ALERT SERVICE BULLETIN

TRANSMITTAL SHEET <u>HC-ASB-61-332</u> Propeller - Spinner Assembly

December 13, 2011

Propeller - Spinner Assembly

Cut-away View of the 835-58(P) Spinner Assembly (For Identification Only) Figure 2

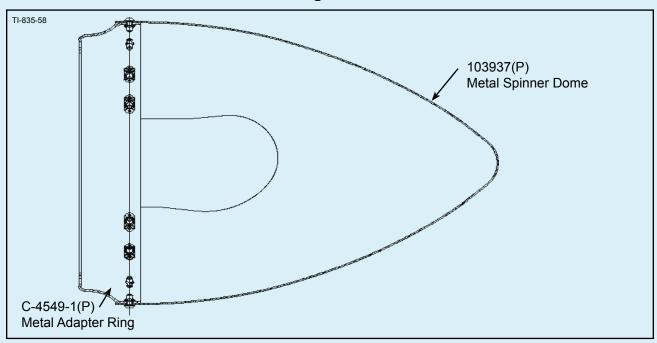
(f) The 835-58(P) spinner assembly was released as a design improvement and as a supersedure in approved applications to all variations of the 835-54(P) spinner assembly. Refer to Figure 2.

- (f) Revision 2 to Hartzell Service Bulletin HC-SB-61-311 introduced the 835-58(P) spinner assembly to supersede the 835-54(P) spinner assembly. Refer to Figure 2 for identification only.

- The 835-58(P) spinner assembly included the 103937(P) metal spinner dome and the C-4549-1(P) metal adapter ring with assembly hardware.
- (g) Revision 2 to Hartzell Service Bulletin HC-SB-61-311 clarified that the existing 835-33(P) spinner assembly is an approved spinner option for the approved applications. Refer to Figure 5.

Cut-away View of the 103585() Spinner Assembly Figure 4

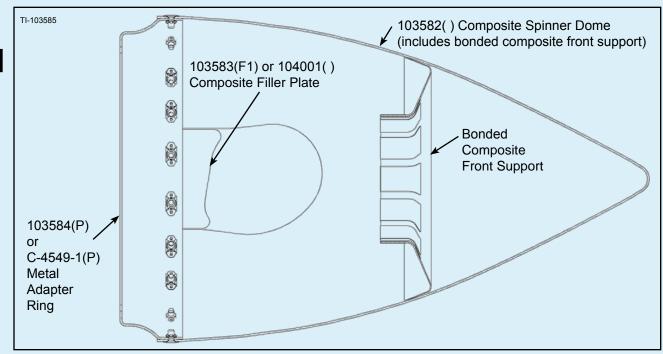
- (d) The 102965(P) metal spinner dome with bonded front support had in-service cracking events as part of the 835-54(P) spinner assembly.
 - (e) The 103585 spinner assembly was released as a design improvement and as a supersedure in approved applications to all variations of the 835-54(P) spinner assembly. Refer to Figure 4.

- (e) Revision 2 to Hartzell Service Bulletin HC-SB-61-311 introduced the 103585() spinner assembly to supersede the 835-54(P) spinner assembly. Refer to Figure 4.

- The 103585() spinner assembly includes the 103582() composite spinner dome, the 104001() composite filler plates, and the 103584P metal adapter ring with assembly hardware.

- (2) Terminating Action:
 - Installation of a 103585() spinner assembly is terminating action for this Alert Service Bulletin.

Example Portion of the Retired Spinner Dome Figure 6

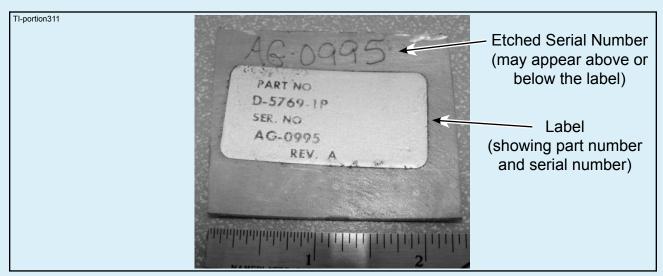
- b) These retired components must not be modified or returned to service for use in any application including experimental applications.
 - c) These retired components must have a portion of the component cut out to include the part number and serial number. Refer to Figure 6. This portion must be returned to Hartzell Product Support.

C-4549-1(P) Metal Adapter Ring Figure 7

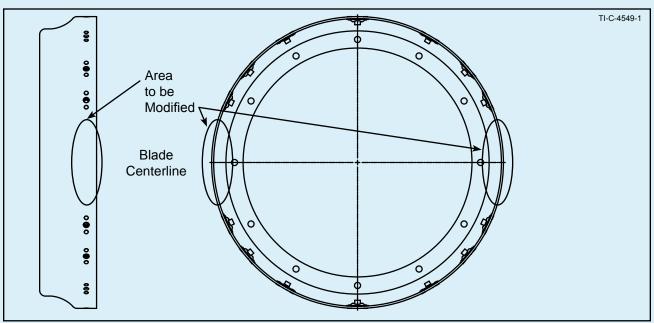
If the 103583() or 104001() composite filler plates will be installed with the C-4549-1(P) metal adapter ring, modification of the adapter ring is required in accordance with the Accomplishment Instructions of this Alert Service Bulletin. Refer to Figure 7 and Figure 8.

- (d) Hold one of the 103583() or 104001() composite filler plates in place, centered in one of the blade cut-out holes, flush with the bottom edge of the adapter ring, aligning the filler plate attachment holes with the row of assembly screws around the dome. Refer to Figure 7 and Figure 9.

- b If the spinner dome does not shift, the spinner dome has a snug fit on the cylinder.
- (6) Using 14 each of the B-3860-10L dimpled washers and of the B-3867-272 10-32 screws, install the 103582() composite spinner dome in accordance with Hartzell Propeller Owner's Manual 115N (61-00-15). Make sure that the screws do not extend more than three threads past the adapter ring nutplates. Refer to Figure 7.

- (7) Using 4 each of the B-3860-10L dimpled washers and the B-3867-272 10-32 screws, install the 103583() or 104001() composite filler plates from the outer diameter of the adapter ring into the newly drilled holes at each blade cutout of the dome. Make sure that the screws do not extend more than three threads past the adapter ring nutplates. Refer to Figure 7.

103584(P) or Modified C-4549-1(P) Metal Adapter Ring Figure 8

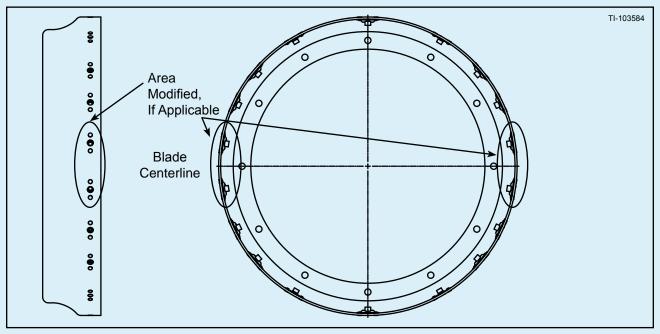
A C-4549-1(P) metal adapter ring can be modified into the 103584(P) metal adapter ring in accordance with this Alert Service Bulletin. This configuration is approved for the 103585() spinner assembly in accordance with this Alert Service Bulletin. The 103585() spinner assembly is only available for purchase from Hartzell with the 103584P (polished) metal adapter ring.

- (i) On the inside diameter of the C-4549-1(P) metal adapter ring, hold one (1) B-3849-3 floating nutplate so that the nutplate is oriented in the same direction as the other nutplates on the inner diameter of the adapter ring and the filler plate attachment hole is aligned with the other assembly holes and with the newly drilled hole. Refer to Figure 7, Figure 8, and Figure 9.

Metal Adapter Ring Identification Labels
Figure 10

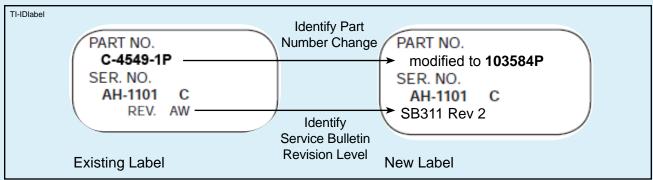
- Type, print, or write on the label to provide the new, modified part number and the original serial number. Include the information as shown in Figure 10.
